Service Bulletin

Bulletin No.: 21-NA-165

Subject: Rattle Noise/Vibration from Under Vehicle

Brand:	Model:	Model Year:		VIN:		Engine:	Transmission:
		from	to	from	to		
Cadillac	CT5	2020	2022	—	—	3.0L (RPO LGY)	—

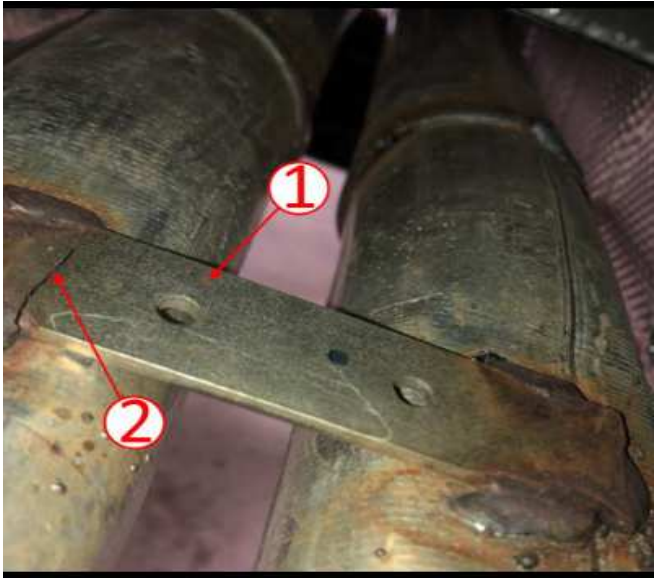
Involved Region or Country	North America, Europe, Middle East, Israel, Cadillac Korea, China
Condition	Some customers may comment that a rattle noise/vibration can be heard emitting from under the vehicle.
Cause	 <p style="text-align: right;">5873316</p> <p>This condition may be caused by a crack (2) in the brace (1) used to space the exhaust system.</p>
Correction	<p>If the brace was found to be the cause of the noise or vibration, remove the brace from the exhaust pipe.</p> <ul style="list-style-type: none"> – The brace is only used to assist installing the exhaust system at the assembly plant and provides no other purpose.

5873317

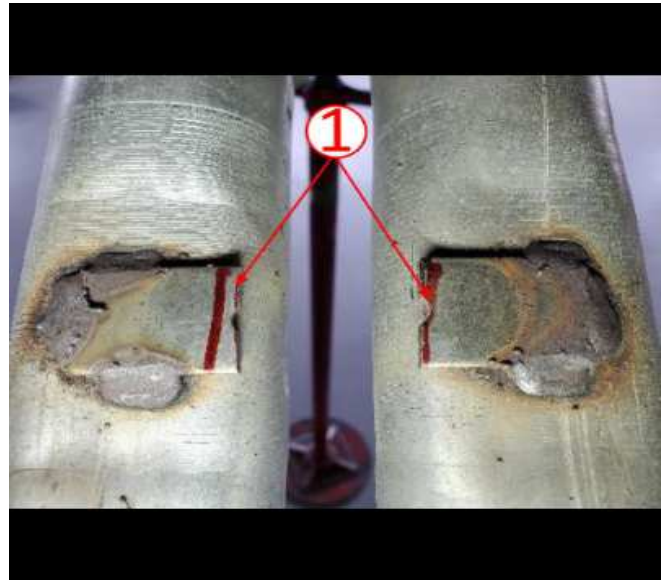
10. Using care, cut the brace as shown in the graphic above.
11. Re-install exhaust system.
12. Reinstall the floor panel tunnel panel front brace.
13. Reinstall the underbody rear air deflector.
